Work Order ID 153688

Item ID: D205-541-044 Accept *N900040100* Setup Start *NS1*
 Revision ID: Stop *NS2*
 Item Name: Bell Medium Heli-Utility-Basket™ - RH
 Start Date: 12/5/2016 Start Qty: 1.00 *1* Cust Item ID:
 Required Date: 12/16/2016 Req'd Qty: 1.00 *1* Customer:
 Reference:

DART SERVICE INSTRUCTION

TO AMEND INSTALLATION INSTRUCTIONS D205-541 REV. J AND
INSTRUCTIONS FOR CONTINUED AIRWORTHINESS ICA-D205-541 REV. 4
REF TCCA STC: SH96-120
REF FAA STC: SR00696NY
REF EASA STC: EASA.IM.R.S.01242

FIGURE 1

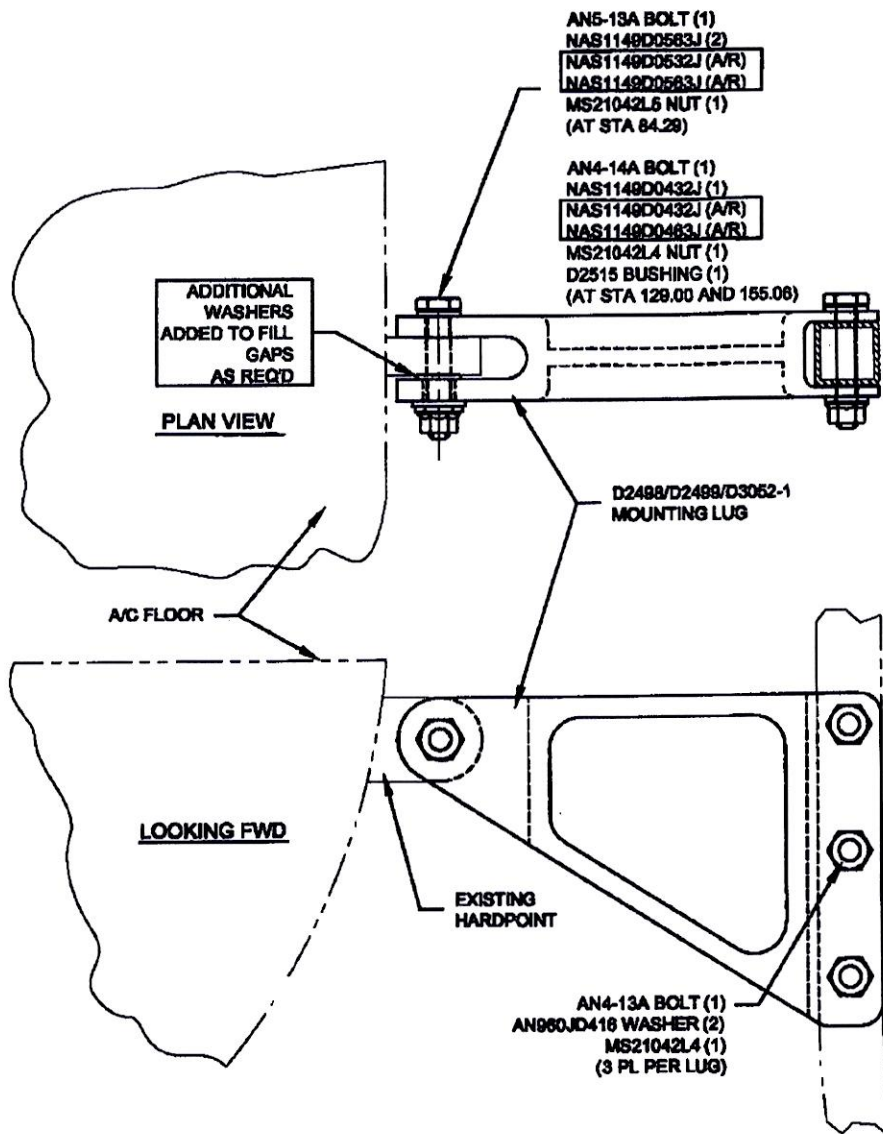
FOR CUSTOMERS/OPERATORS CONCERNED WITH GAPS AT STA's 84.29, 129.00 AND 155.06 WHILE INSTALLING D205-541-043/-044/-045/-046 BASKETS, IT IS ACCEPTABLE TO FILL THE GAPS WITH WASHERS TO REDUCE UNNECESSARY STRESS ON THE MOUNTING LUGS.

INSTALL THE D205-541-043/-044/-045/-046 BASKET KITS PER INSTALLATION INSTRUCTIONS D205-541 WITH ADDITIONAL WASHERS AS SHOWN IN FIGURE 1 OF THIS SERVICE INSTRUCTION.

4	4	4	4	NAS1149D0463J	WASHER
4	4	4	4	NAS1149D0432J	WASHER
2	2	2	2	NAS1149D0532J	WASHER
2	2	2	2	NAS1149D0563J	WASHER
